# **DEVELOPMENT APPLICATION ASSESSMENT REPORT**

Application Number:	DA2021/1014	
Responsible Officer:	Adam Mitchell	
Land to be developed (Address):	Lot 17 DP 33000, 61 Aubreen Street COLLAROY PLATEANSW 2097	
Proposed Development:	Alterations and additions to Dwelling House including a carport and swimming pool	
Zoning:	Warringah LEP2011 - Land zoned R2 Low Density Residential	
Development Permissible:	Yes	
Existing Use Rights:	No	
Consent Authority:	Northern Beaches Council	
Land and Environment Court Action:	No	
Owner:	Paula Samantha Herrington Wayne David Martin	
Applicant:	Site Specific Designs	
Application Lodged:	07/07/2021	
Integrated Development:	No	
Designated Development:	No	
State Reporting Category:	Residential - Alterations and additions	
Notified:	14/07/2021 to 28/07/2021	
Advertised:	Not Advertised	
Submissions Received:	0	
Clause 4.6 Variation:	4.3 Height of buildings: 2%	
Recommendation:	Approval

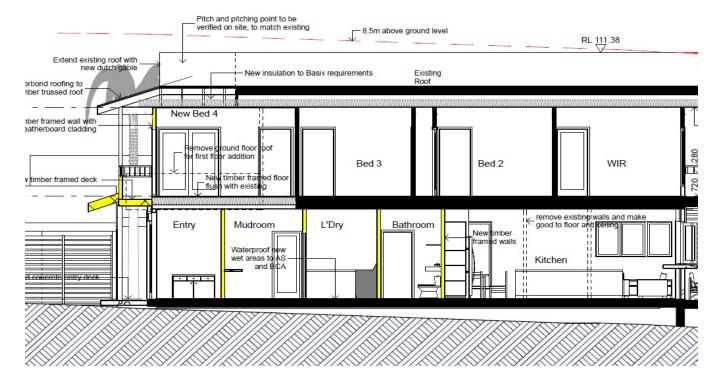
It is concurred with the applicant that the proposed breach of the prescribed building height is architectural in nature and allows the continuation of the existing roof-form. The works as a whole represent a superior design outcome commensurate to the existing building, and no impact has been identified as being caused by the breach. An extract of the sectional plan showing the non-compliant portion of the building is below, highlighted in red in the top-right:

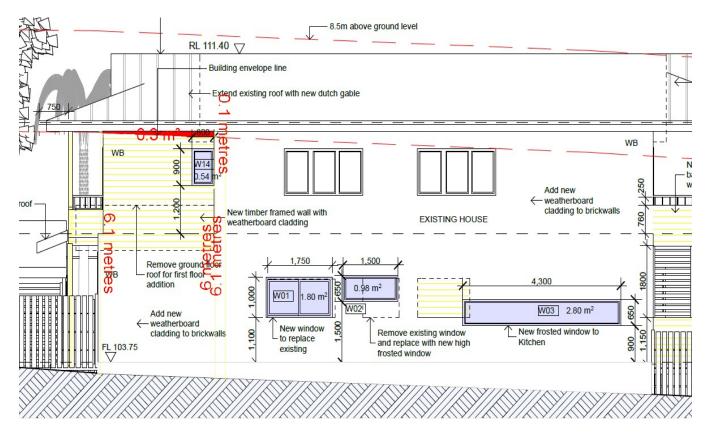
Clause B3 of the DCP requires a 5m side boundary envelope to the flank elevations of the building. Both elevations of the existing building breach the envelope, and the front extension continues this breach to the southern elevation, as highlighted in red on the below snippet from the plans:
